UNITED STATES PATENT AND TRADEMARK OFFICE

APPLICATION NO.	FILING DATE	FIRST NAMED INVENTOR	ATTORNEY DOCKET NO.	CONFIRMATION NO.
10/047,754	01/14/2002	Varadarajan Srinivasan	002489.P036	5133

Office Action Summary

DETAILED ACTION

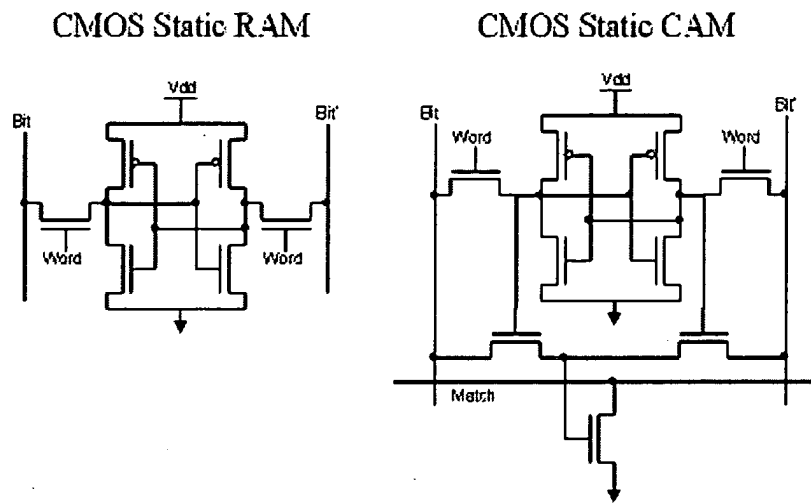
Guccione presents a circuit diagram of a RAM versus CAM cell in Figure 1, where it is clear that the CAM circuit comprises a memory element paired with a compare circuit:

“Figure 1 shows transistor level diagrams of both CMOS RAM and CAM circuits. The circuits are almost identical, except for the addition of the match transistors to provide parallel search capability” (§ 2, paragraph 3).

“Clearly this transistor level implementation is efficient and may be used to produce CAM circuits which are nearly as dense as comparable static RAM circuits” (§ 2, paragraph 5).
